Addendum #2

Project Name: Cattle National Bank & Trust - Fallbrook
6550 Merchant Drive
Project No.: 12054
Issued: May 06, 2013
Bid Date: 2:00 pm, CDT May 14, 2013

Revision to Detail **A5/A701**

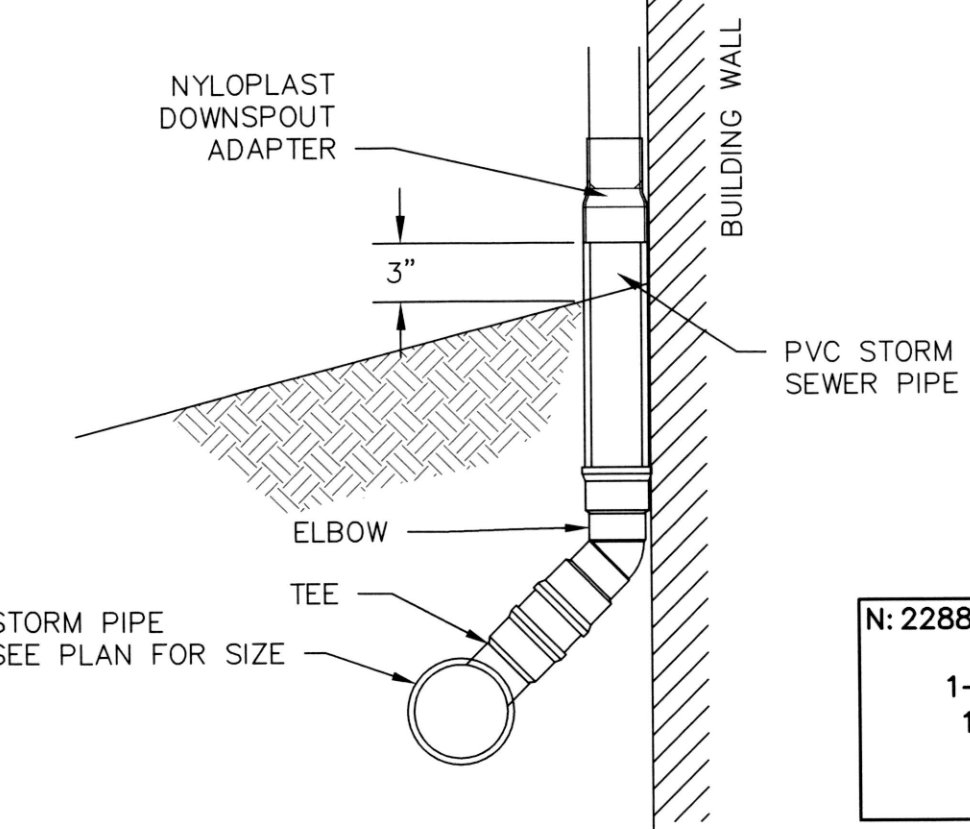
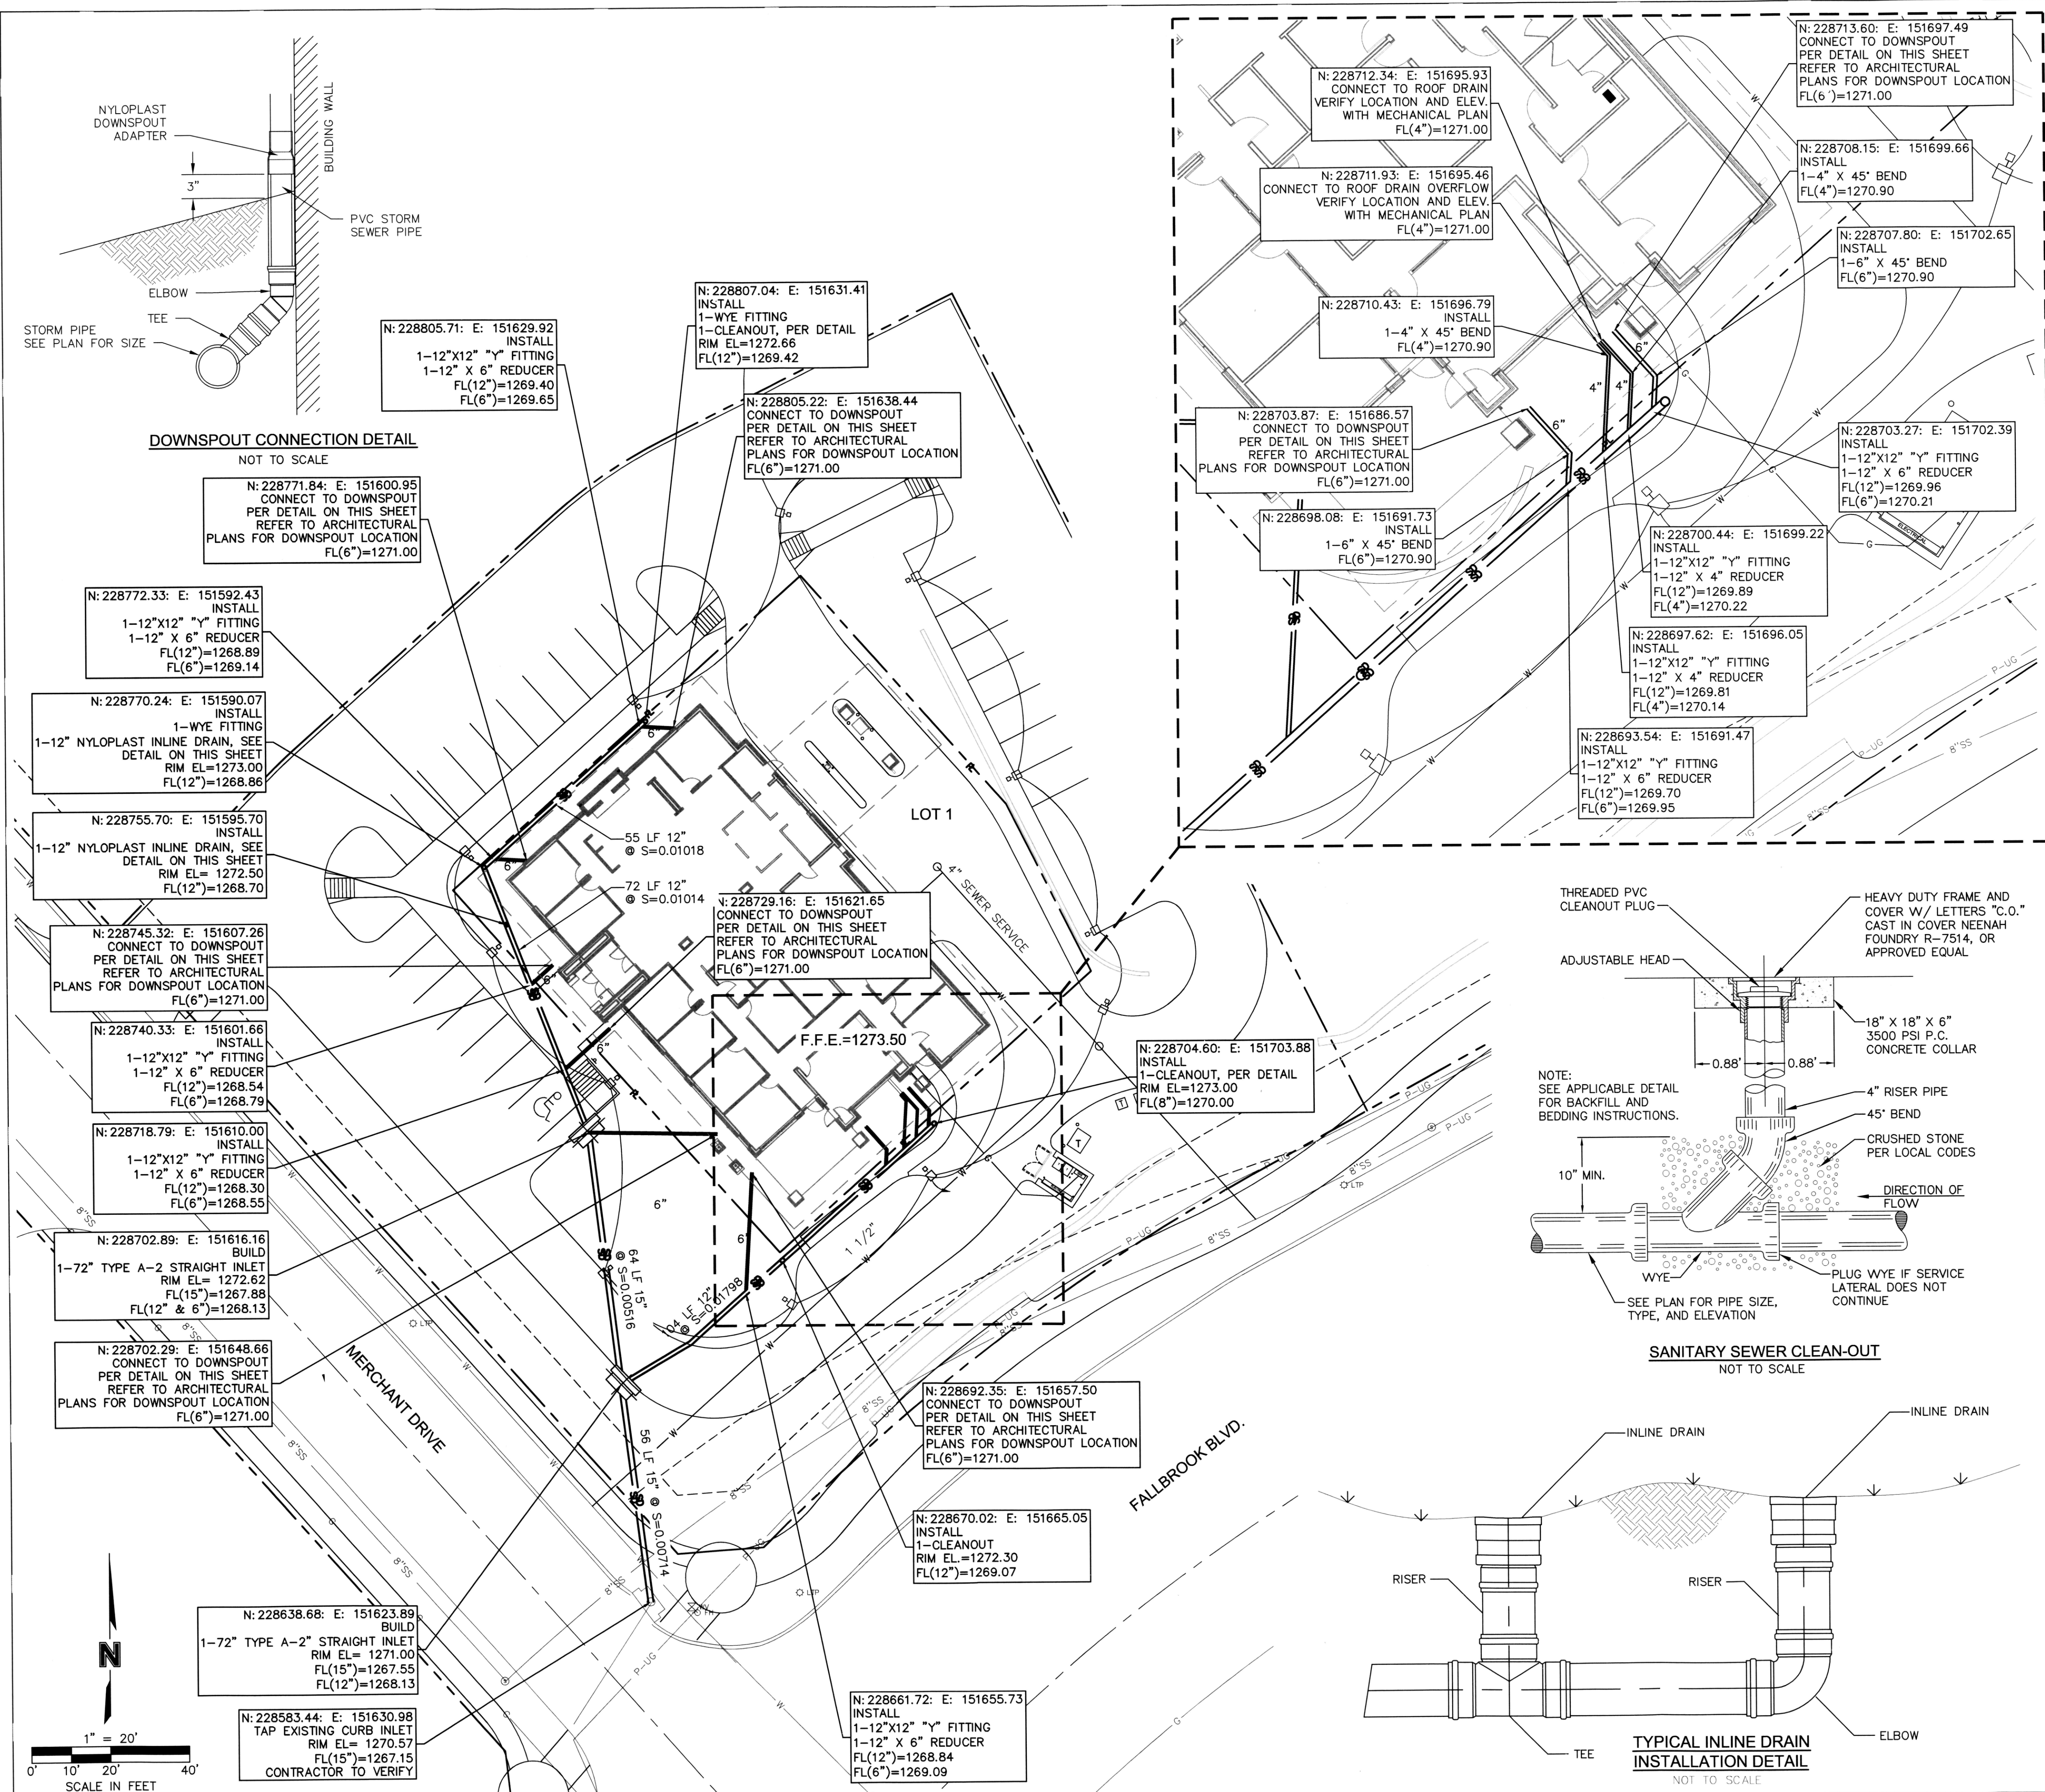
- b. A5/A701: Added note and dimensions. Refer to Attachment A04.

STORM SEWER PLAN
SHA PROJECT NO. 12054
C3.02

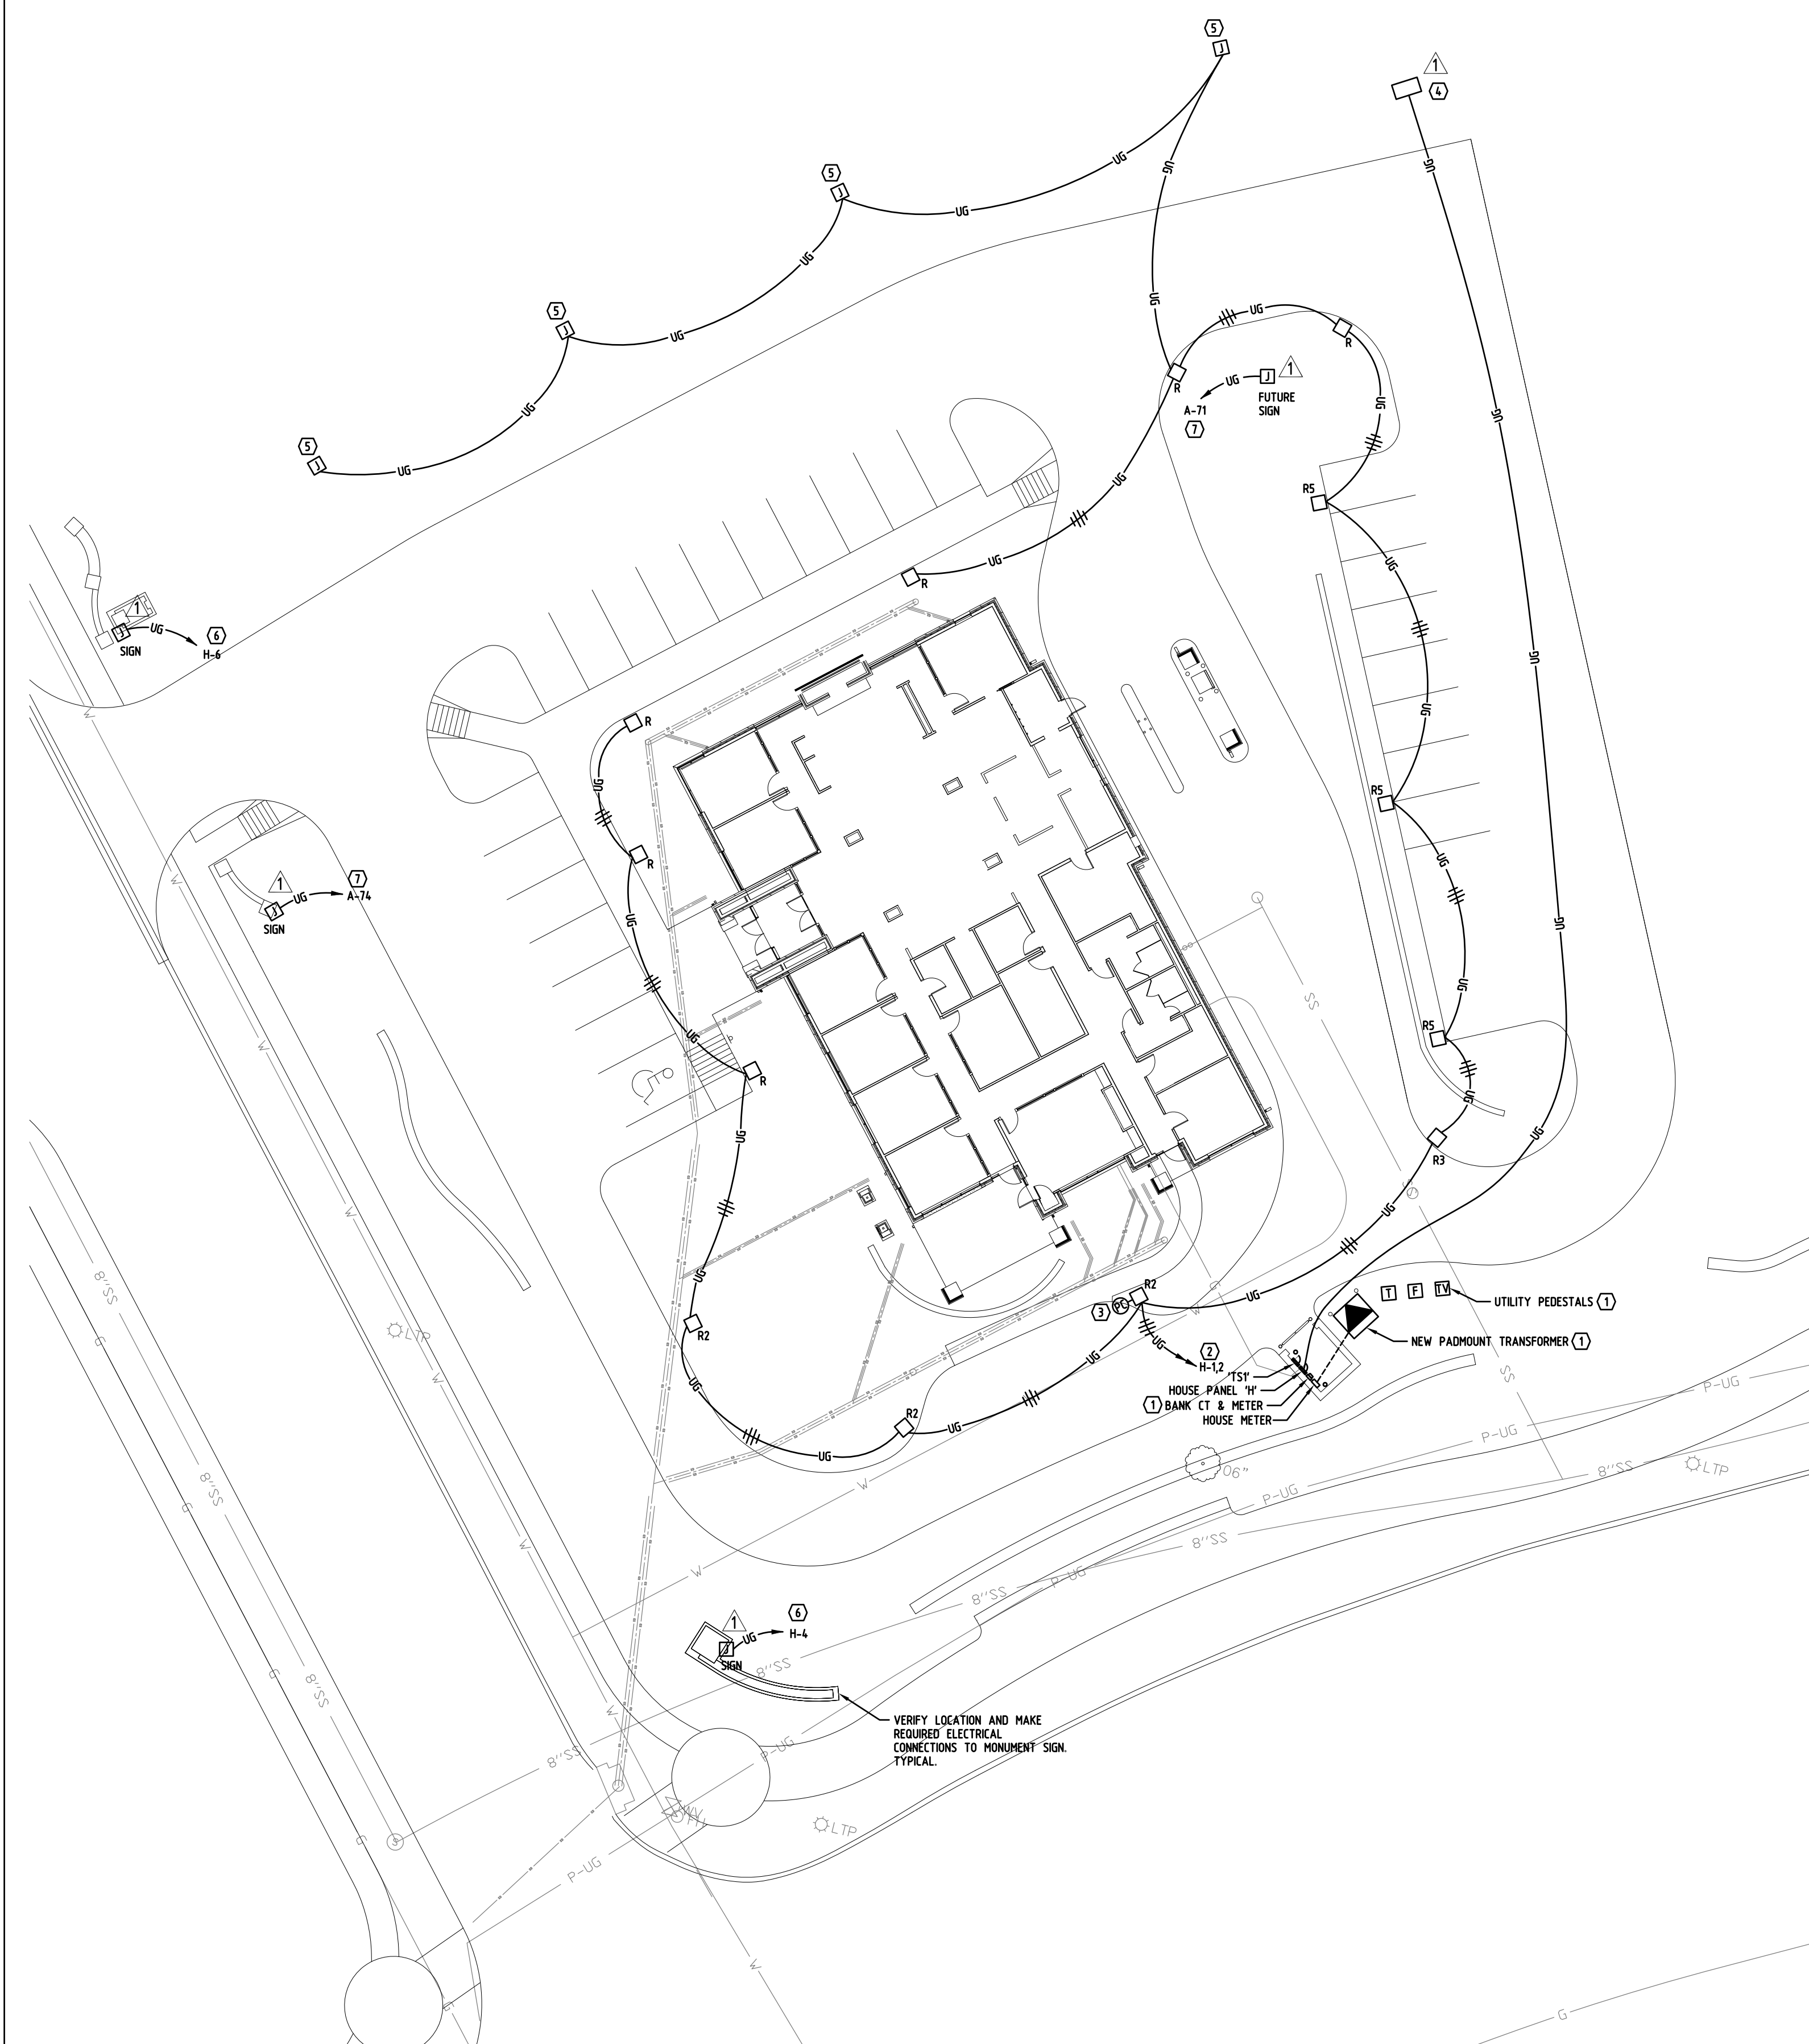
- a. Added Sheet C3.02 Storm Sewer Plan

A5 ELECTRICAL SITE PLAN - PROPERTY

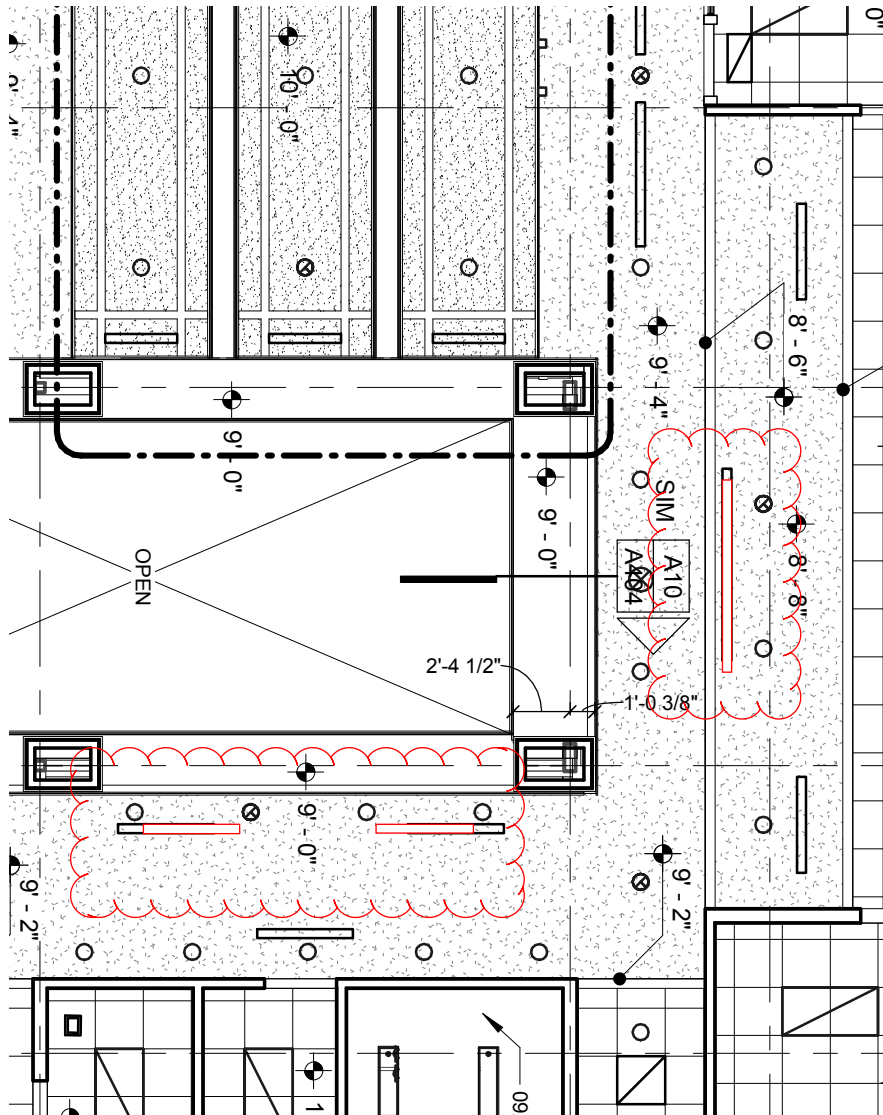
- a. See attachment E001P for changes noted with Revision '1' notes.
